SERVICE BULLETIN

SUBJECT: INSPECTION AND REPAIR OF AFT FUSELAGE SKIN CRACKS;
INSTALLATION OF DOUBLERS ON BOOM FAIRING LOWER
LONGERONS

MODELS AFFECTED: 500D Model 369D Helicopter Serial No. 0003D thru 0529D

Figure 1. Figure 1. Field Modification - 369D23018-1 and -2 Boom Fairing Longerons

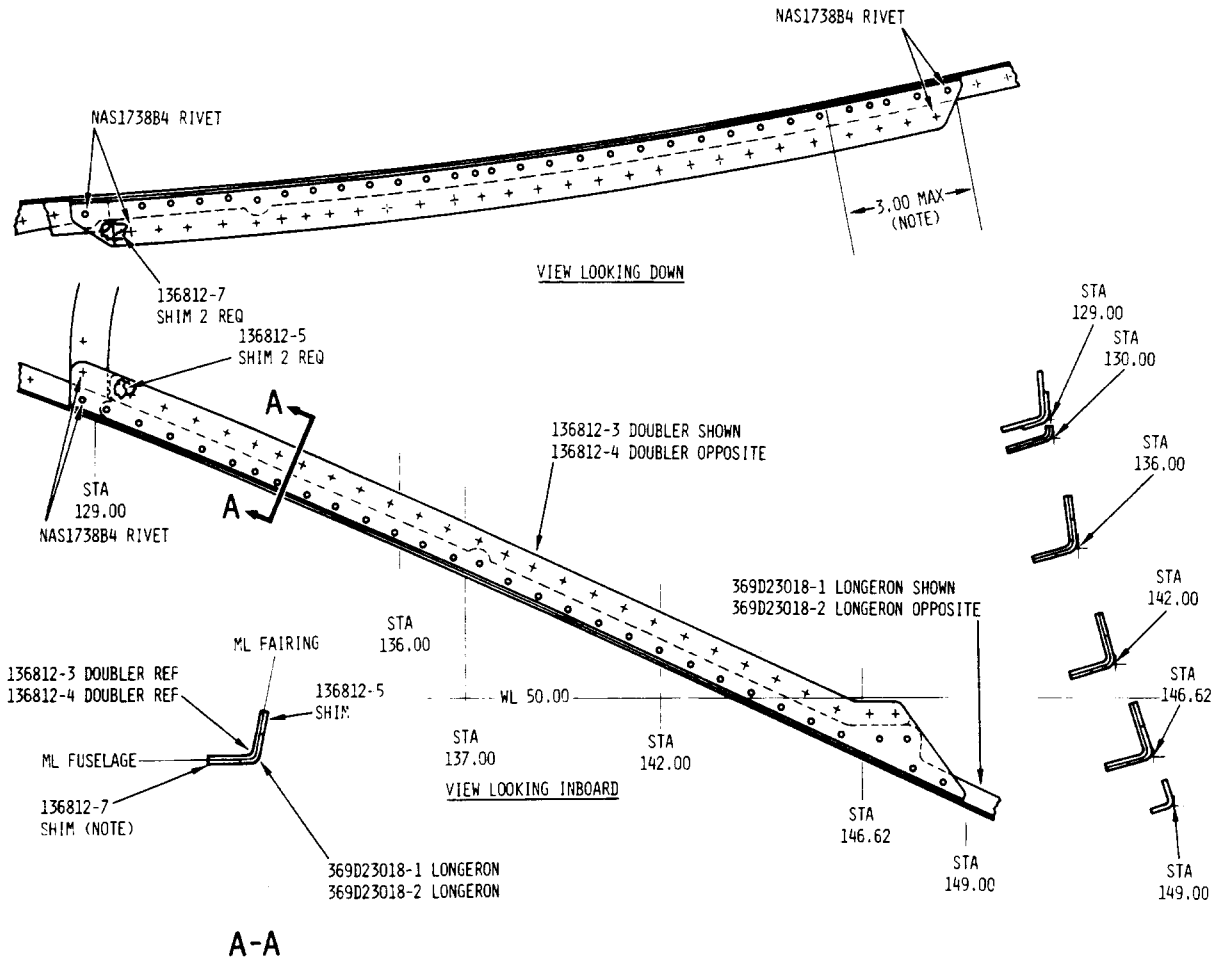
b. Drill out existing rivets securing 369D23018-1 and -2 boom fairing lower longerons to fuselage structure and skin, between Station 129.00 and Station 149.00, as shown in Figure 1.

c. Position and nest -3 and -4 doublers in place in longerons; mark and drill rivet holes in doublets to match rivet pattern in longerons.

If rivets are in radius of -3 or -4 doublers, relocate rivet adjacent to problem hole (approximately 3.5 x rivet diameter spacing) and maintain a minimum of 1.5 x rivet diameter edge distance on 369D23018 longeron.

For Model 369MD (Military) Helicopters equipped with Black Hole Ocarina (BHO) Infrared Suppressor System, trim up to 3.00 inches (maximum) on No. 136812-7 shim on installation (See Figure 1.)

- d. Install doublets temporarily on longerons with Cleco fasteners or equivalent. Position -5 and -7 shims in place on each doublet as shown. Mark and drill rivet holes in doublets and shims. Install shims to doublets with NAS1738B4 rivets; install rivets with wet zinc chromate primer.
- e. Remove Cleco fasteners and install doublers with NAS1738B4 rivets. Rivets may be installed from inside or outside engine compartment; install rivets with wet zinc chromate primer.
- f. Remove all debris from work area; inspect modification of longerons for discrepancies.
- g. Reinstall heat blanket/firewall with existing fasteners.
- h. Record compliance with Part II of this Notice in Compliance Record of helicopter Log Book.

NOTE:
TRIM UP TO 3.00 INCHES MAXIMUM AS SHOWN
ON SHIM NO. 136812-7, FOR 369MD HELICOPTER
EQUIPPED WITH INFRARED SUPPRESSOR SYSTEM.
